CITY OF OREGON CITY

3a. AP 21-00004 and AP-21-00005, Two appeals of Planning Files GLUA-21-00002: SP-21-00001 / LL-21-00002 for a Lot Line Adjustment and Site Plan and Design Review for a 60-Unit Residential Condominium Project on Holmes Lane - Neighborhood Association Fee Waiver Request Associated with One Appeal

Staff Report

AP 21-00004 and AP-21-00005, Two appeals of Planning Files GLUA-21-00002: SP-21-00001 / LL-21-00002 for a Lot Line Adjustment and Site Plan and Design Review for a 60-Unit Residential Condominium Project on Holmes Lane - Neighborhood Association Fee Waiver Request Associated with One Appeal

Site Plan

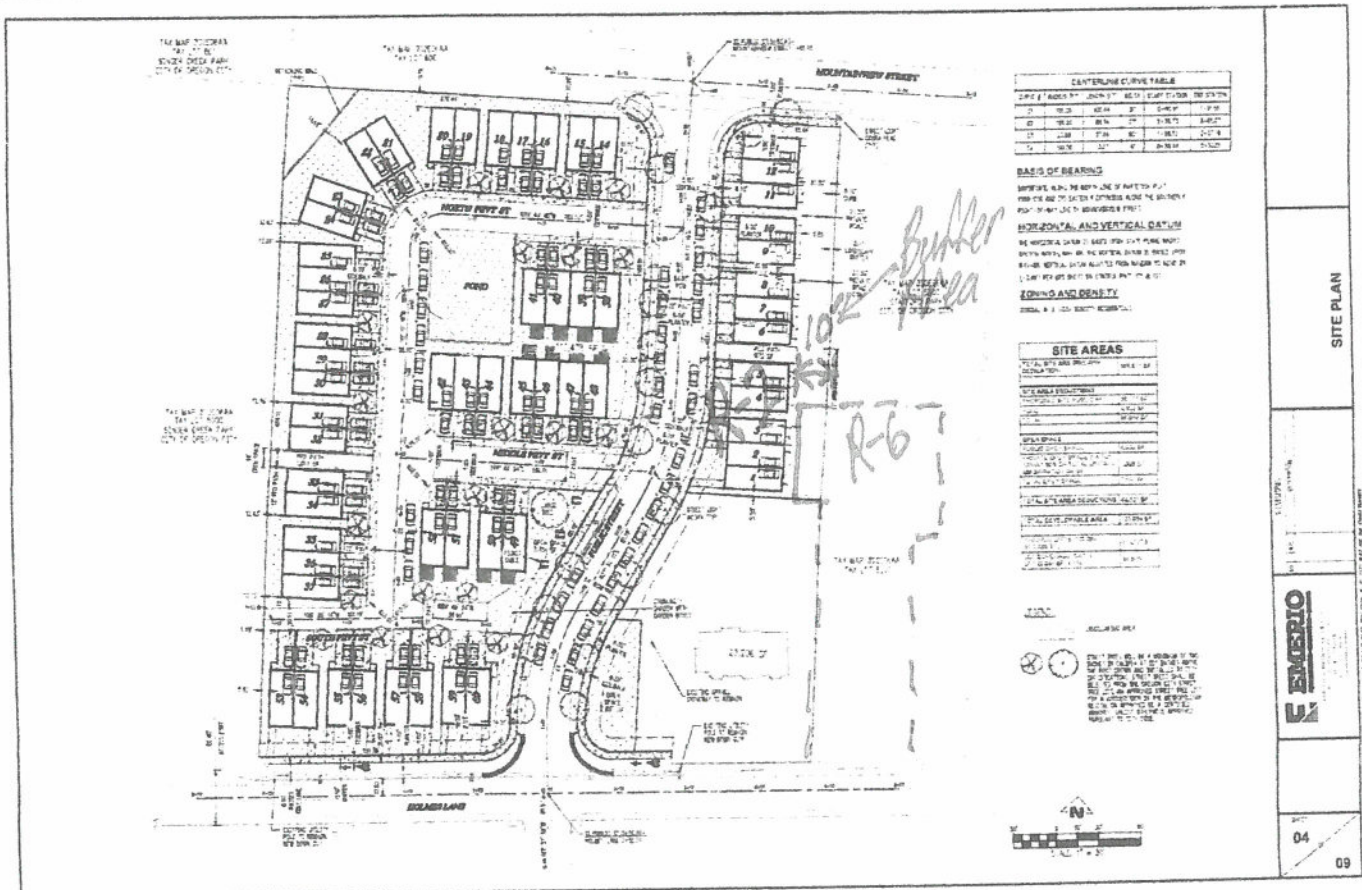
Picture shows 3 Feet from Surveyors Bench
Mark Between Fence post and Metal Fence Post.
Developers Drawing Shows a five Lane at
this point. Clearly not a 10" Buffer

Item #4 Parking. There will not be enough parking for the number of residents living in the new 60 unit project. No parking allowed in the Five Lanes. No Resident Parking in Stafford Park. No Parking on Holmes Lane. No Parking on Mountain View Street.

The findings of the report are from 2018, not 2020. Page 11 peak hour rate only includes 28 cars in the am, and 34 cars in the PM. This number is half of the total units = 60, and does not include other traffic.

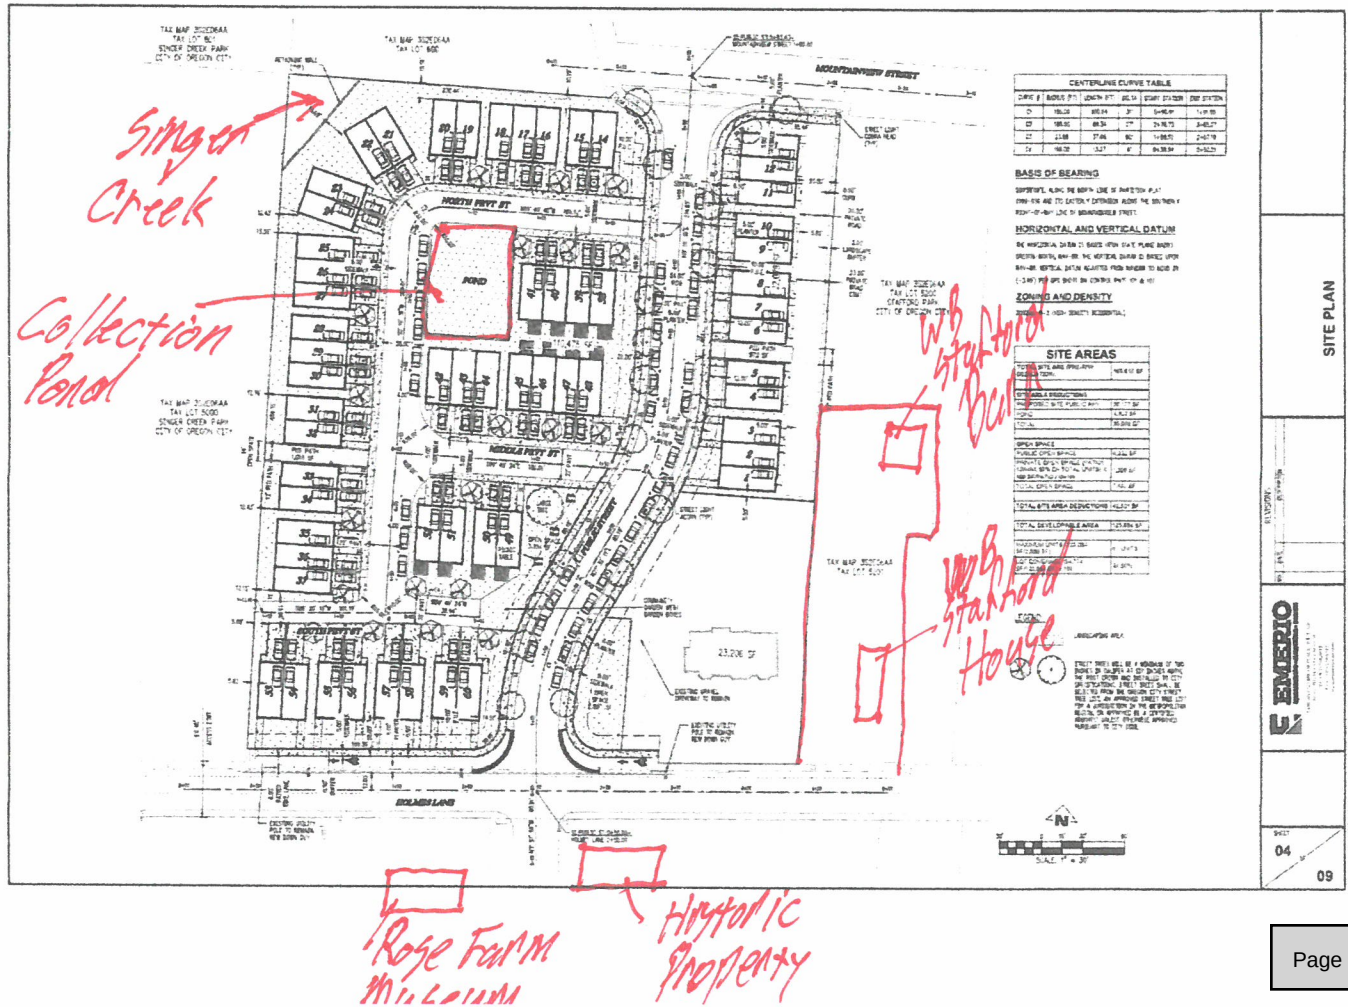
If you put the 60 unit condominiums
up you will have a lot of problems
like more wrecks, and cars killed
more speeding, using drugs, a lot
of needles, they will use the park
for a bathroom, will not be
quit more cars on ~~the~~ Mountain View
and Holmes Ln. more shootings
and cans, trash, Bottles everywhere
